Project	IEEE 802.16 Broadband Wireless Access Working Group < http://ieee802.org/16 >	
Title	MIH C-SAP Primitives	
Date Submitted	2006-03-07	
Source(s)	David Johnston Intel Corporation 2111 NE 25th Ave Hillsboro, OR, 97006 USA	Voice: +1 503 264 3855 Fax: +1 503 264 3483 dj.johnston@intel.com
Re:	Doc IEEE 802.16g-D1	
Abstract	Provides the missing C-SAP primitives to carry the MIH 802.21 Frames.	
Purpose	To enable the carriage of 802.21 MIHF frames over the C-SAP to be mapped onto the 802.21 MIH-SAP.	
Notice	This document has been prepared to assist IEEE 802.16. It is offered as a basis for discussion and is not binding on the contributing individual(s) or organization(s). The material in this document is subject to change in form and content after further study. The contributor(s) reserve(s) the right to add, amend or withdraw material contained herein.	
Release	The contributor grants a free, irrevocable license to the IEEE to incorporate material contained in this contribution, and any modifications thereof, in the creation of an IEEE Standards publication; to copyright in the IEEE's name any IEEE Standards publication even though it may include portions of this contribution; and a

Figure 504—MIH Primitive Flow between 802.16 Entity and NMCS for 802.21 Support

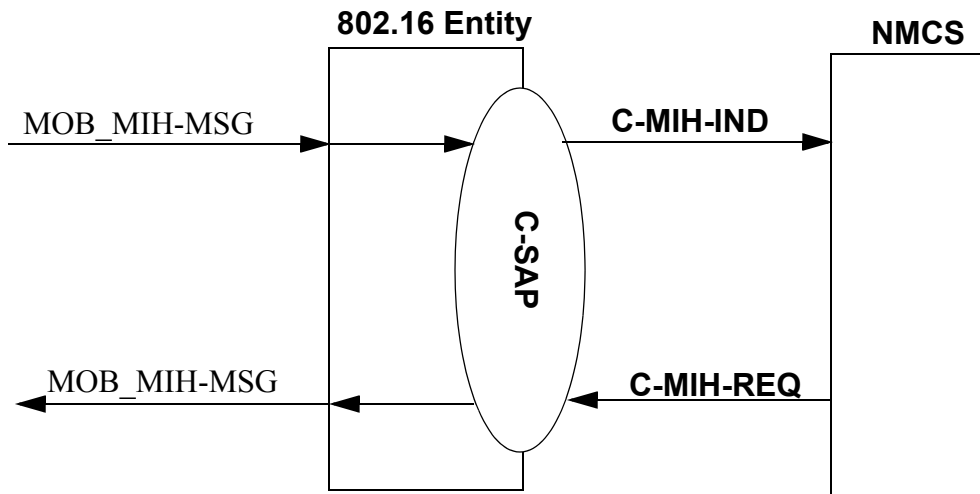
Insert new text into 802.16g, 14.2.9.8:

The MIH Control Primitives provide carriage of 802.21 MIHF Frames between the 802.16 entity and the NMCS. This enables the NMCS to map between MIHF frames and primitives on the 802.21 MIH-SAP, consistent with Clause 5.5.3 of IEEE Std 802.21.
